**BROWNS FERRY NUCLEAR PLANT (BFN) - UNITS 1, 2, AND 3 -  
TECHNICAL SPECIFICATION (TS) 375 - CHANGE IN OPERABILITY  
REQUIREMENTS FOR REACTOR VESSEL WATER LEVEL INSTRUMENTATION**

#### PROPOSED TECHNICAL SPECIFICATION (TS) CHANGE TS-375 DESCRIPTION AND EVALUATION OF THE PROPOSED CHANGE

FIGURE 1  
Reactor Vessel Water Level Instrumentation

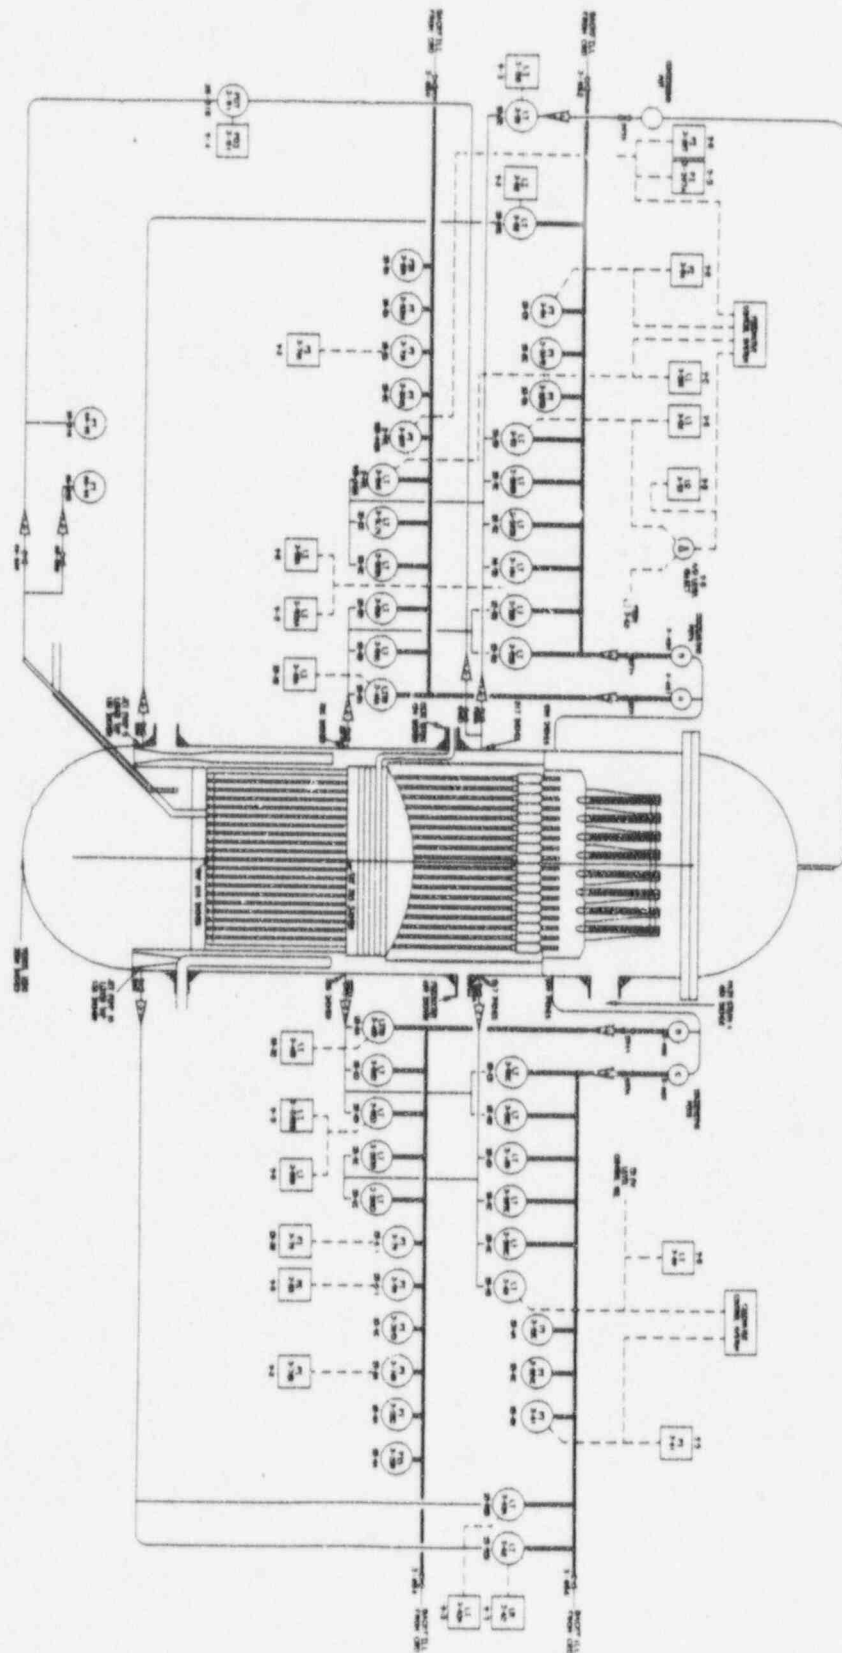
Despite the fact that the minimum Technical Specification required number of reactor vessel water level trip systems will not be operable during the period that the reactor coolant system instrument line flow check valve surveillance tests are being performed, only one variable leg will be removed from service at a time. The other variable leg and its associated reactor vessel water level instrumentation will remain in service and be capable of initiating the Core Spray System, LPCI, and the multiplier relay from the Core Spray System that, in conjunction with drywell high pressure, initiates an accident signal. However, this resulting configuration is not single failure proof.

In addition to the remaining leg (either LS-3-58A-B or LS-3-58C-D) being available for automatic initiation, the following reactor vessel water level instrumentation will not be affected by the proposed modifications and will remain in service:

While this instrumentation is not configured to substitute for the automatic initiation of the reactor vessel water level instrumentation that is being removed from service (either LS-3-58A-B or LS-3-58C-D), it will provide the operators with reactor vessel water level indication. In case of a single failure in the remaining variable leg (either LS-3-58C-D or LS-3-58A-B), the operators would manually initiate the Core Spray System and LPCI, as appropriate.

FIGURE 2  
 Reactor Vessel Water Level Instrumentation Initiating Logic

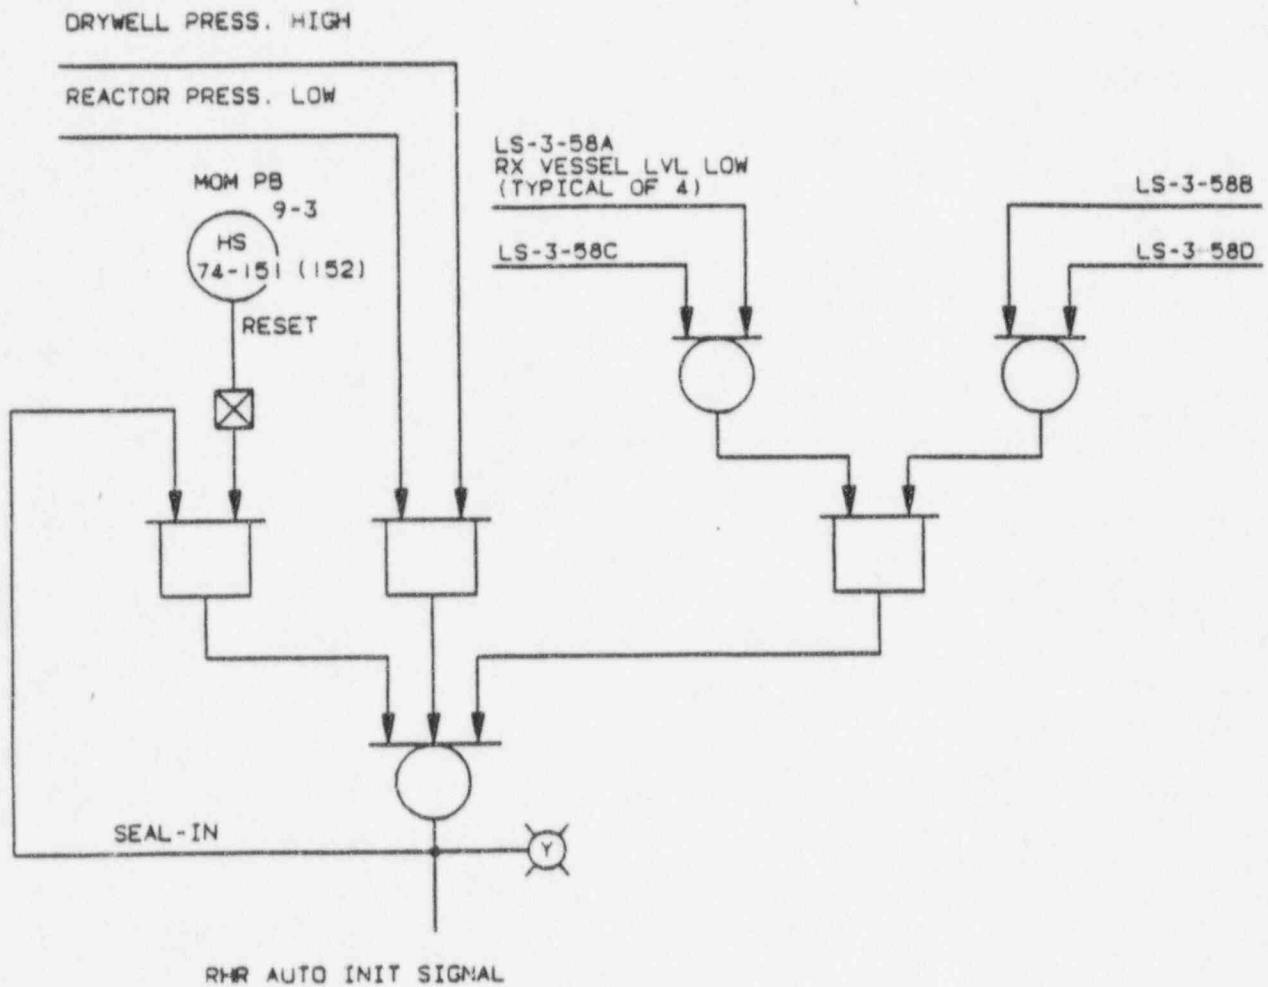
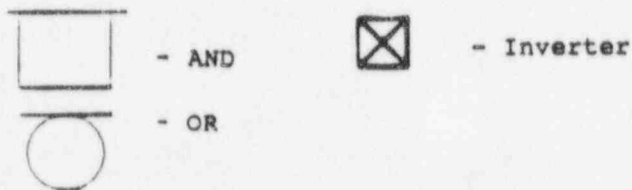
The LPCI and Core Spray Low Pressure Permissives for the injection valves are not inhibited by the isolation of a single variable leg during primary system hydrostatic testing.

Therefore, requiring only one trip system for the reactor low water level instrument channel (LS-3-58A-D) be operable during the period that the reactor coolant system instrument line flow check valve surveillance tests are being performed is justified due to:
